Wisconsin Department of Transportation

Proposal #20: 2200-16-71
Moreland Boulevard
Manhattan Drive to I-94
USH 18
Waukesha County

This is Addendum No. 03, which provides for the following:

Addendum No. 03
 ID 2200-16-71
 Revised Sheet 24
 January 7, 2016

ADJUSTING MANHOLE/INLET COVERS

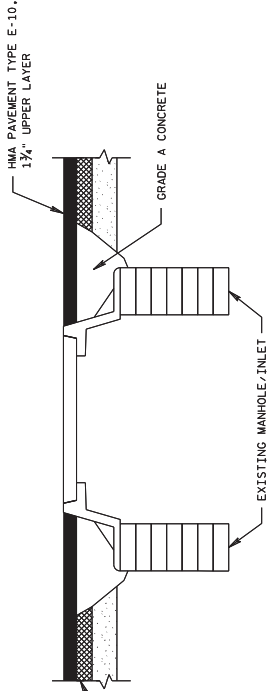
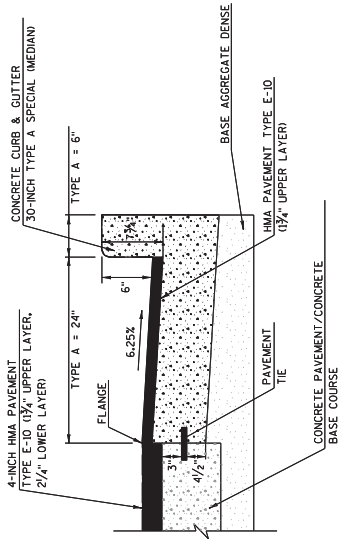
Revised Plan Sheets	
Plan Sheet	Plan Sheet Title (brief description of changes to sheet)
24	Construction Detail – Changed notes to clarify items that are incidental to Adjusting Manhole Covers and Adjusting Inlet Covers

WORK LISTED ABOVE IS INCLUDED OR IS CONSIDERED INCIDENTAL TO PAY ITEMS ADJUSTING MANHOLE COVERS OR ADJUSTING INLET COVERS.

C. METHOD OF MEASUREMENT AND BASIS OF PAYMENT
 TEMPORARY COVER PLATES, WHEN REQUIRED, ARE CONSIDERED INCIDENTAL TO THE WORK OF ADJUSTING MANHOLE COVERS AND ADJUSTING INLET COVERS. THE STEEL PLATES SHALL BECOME THE PROPERTY OF THE CONTRACTOR WHEN NO LONGER NEEDED IN THE CONTRACT WORK.
